SUBJECT: **Detroit[™] DT12[™] Split Rod Bushing Repair**

Note: This document supersedes Technical Service Letters 16 TS-22 and 17 TS-10.

Figure 2 – New Steel Bushing Installed

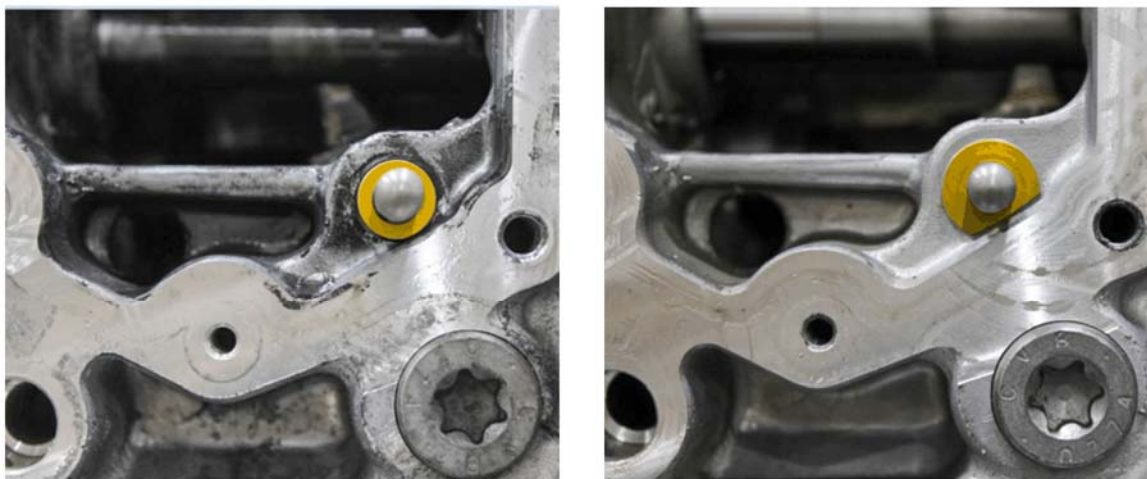
See Figure 2 below for two different steel bushing designs that were implemented in production of new transmissions. Both styles below are new designs and do not need to be replaced in service.

If you have the ream and bushing update, either of the new style steel bushings can be installed into the reamed bushing.
